CITY OF PORTLAND, MAINE

Project Name: AC Hotel
Address: 158 Fore Street
Applicant: Portland Norwich Group

Project ID: 2015-169
CBL: 19-B-2
Planner: Nell Donaldson

AC Hotel
158 Fore Street
Level III Site Plan and Subdivision Review
2015-169
Portland Norwich Group

Figures 4 and 5: Hancock Street elevation (top); final site plan (left).

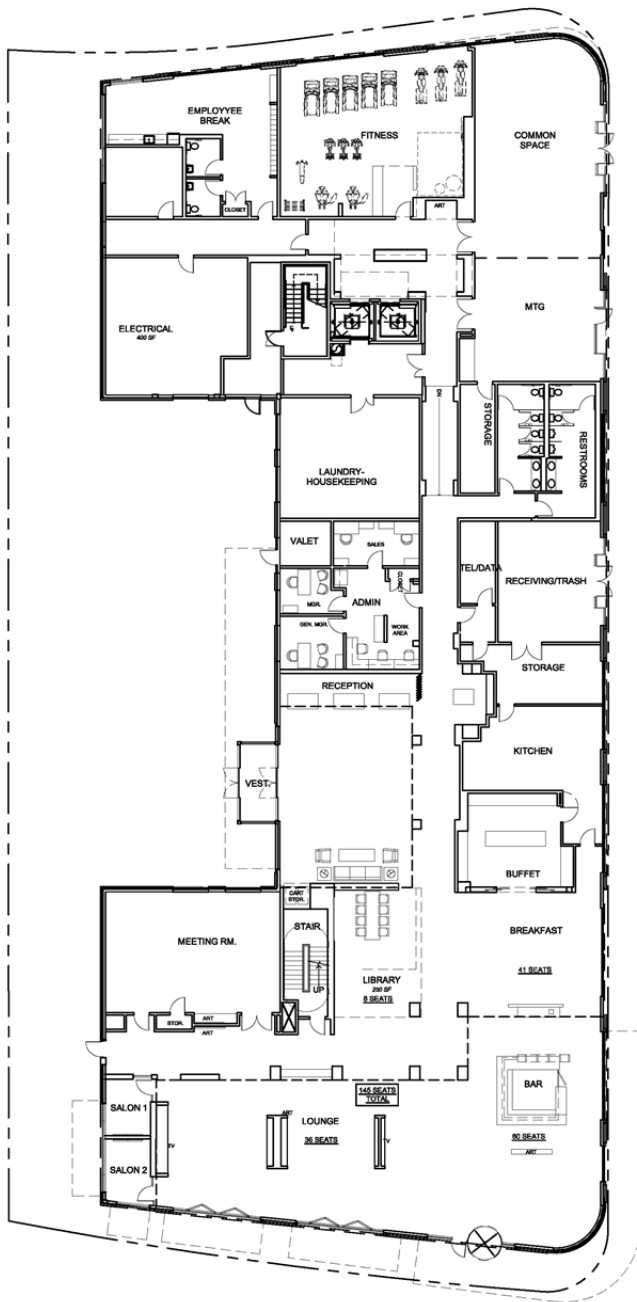
It is my recommendation that a crosswalk be implemented on the west side of Fore Street at Hancock Street (particularly given use of the Gateway Parking Garage by the project). The crosswalk may include warning signs and shall be fully ADA compliant on both sides of Fore Street...A condition of approval shall be included that requires the applicant to provide final ADA crosswalk, signage, and ramp details for review and approval. The applicant shall be responsible for implementation of the recommended design details. I would note the design shall be the preferred perpendicular crosswalk alignment and include ramps on both sides of Fore Street.

City staff continues to review the curb extension at the southwest corner of the Fore Street/Hancock Street intersection. Alterations to the ramp configuration and depth of the extension will be required...I would also note that the applicant will be reconstructing the Hancock Street/Thames Street corner and the current curb extension as depicted on the site plan will need to be modified from geometric and ramp configuration perspectives. The City will provide direction on the configuration.

The driveway/alley is proposed approximately 120 feet to the west of the Fore Street/Hancock Street intersection, short of the city's 150 foot technical standard for corner clearance. The applicant has requested a waiver for this condition (*Attachment I*). Mr. Errico writes,

Fore Street is classified as a Collector Street and City standards require 150 feet of corner clearance to Hancock Street. I support a waiver from City standards given that the location of the driveway is approximately midblock between Hancock Street and

India Street. The applicant has maximized corner clearance and the separation standard is almost met (120 feet of corner clearance will be provided). As noted above I support a waiver from City standards.

8. The applicant shall revise plans to depict ADA-compliant perpendicular crosswalks and provide sign and ramp details at Fore and Hancock Streets and Fore and Thames Streets for review and approval by the Department of Public Works;
